**MASTER DEVELOPMENT PLAN
 for
 MOOS TRACT 848-A**

Re: Moos Tract (Amendment)

MDP # 848-A

The City Staff Development Review Committee has reviewed Moos Tract Master Development Plan **MDP# 848-A (amendment)**. Please find enclosed a signed copy for your files. Your plan was accepted. However, please note the following conditions:

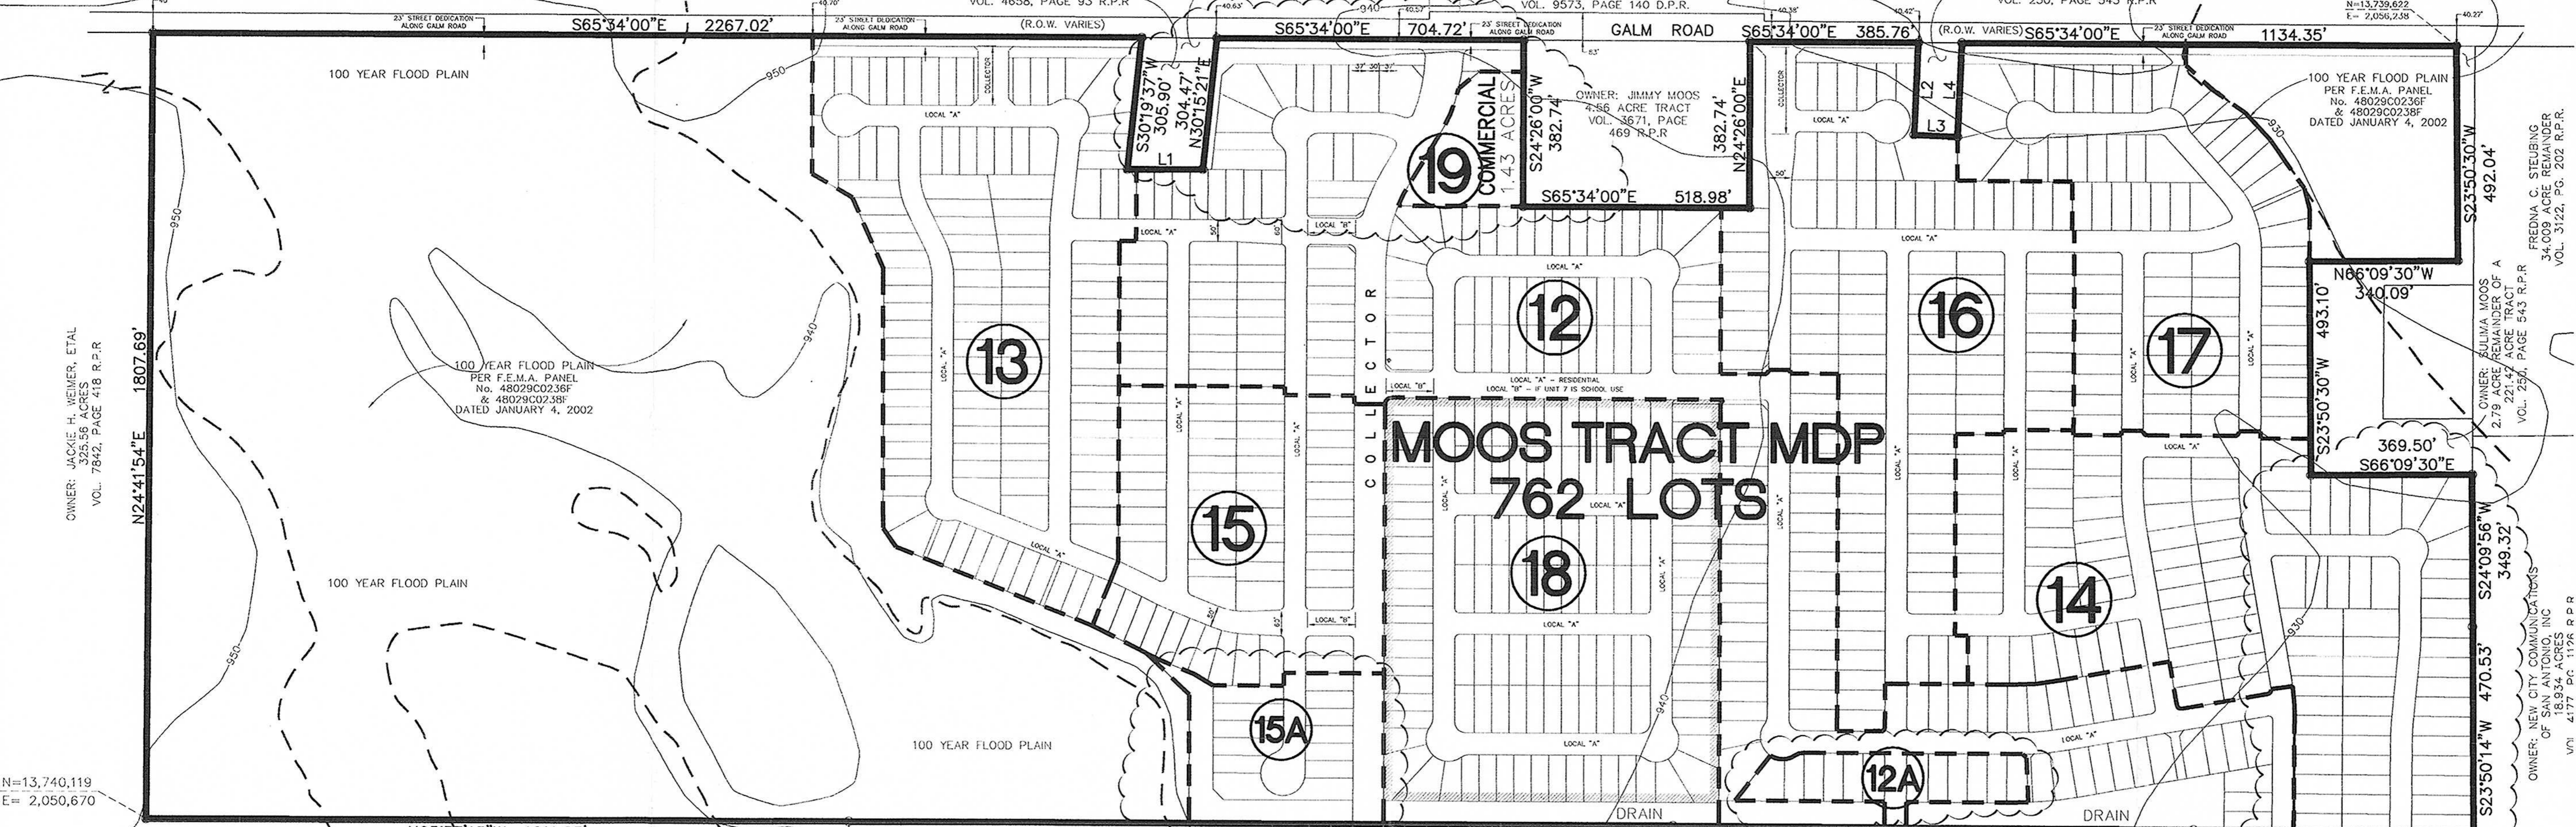
In consideration of public safety and convenience, excessive grades by reason of topography should be avoided in street layouts and arrangements. Any access and right-of-way issues along state facilities will need to be resolved with the **Texas Department of Transportation (TXDOT)**. For information about these requirements you can contact TXDOT at 615-5814.

Development Services Department – Traffic Impact Analysis & Streets indicate that under the UDC listed below are some of the requirements and onsite improvements that are necessary and shall be provided by the developer, on and before the completion of Moos Tract MDP, at no cost to the City of San Antonio:

- All access driveways shall comply with UDC 35-506(r).
- All roadways shall conform to Table 506-2 functional classification system description for traditional design classification.
- All sidewalks shall comply with UDC 35-506(q).
- All access roadways shall provide clear sight distance on all existing and proposed roadways in order to provide adequate obstruction free viewing distances for approaching traffic. All signage, landscaping, and improvements shall be selected and located so as to not block these clear sight distance areas.
- The on-site improvements referenced on the approval letter for MDP# 848 dated February 1, 2005 still apply.

- The total amount of fee in lieu to be paid is \$14,915.84.
- The required amount to be paid is \$2,226.24 per acre.
- The fees are to be paid per plat in order to release for recordation.

- 2003 Tree Preservation ordinance standards per UDC Section 35-523 – a Tree Preservation Plan is required prior to any work on site. This can be submitted either as a site work permit or at the platting stage.
- Streetscape standards per UDC section 35-512 – Galm Road requires streetscape planting.
- Additional permitting fees and affidavits will be needed to obtain tree permits during the platting and/or building permit stages.

- It is understood that this MDP is a conceptual plan and all regulations will be addressed at time of platting. Bexar County reserves the right to address driveways, street design, sight distance, ADA requirements, drainage and floodplain issues at time of platting.
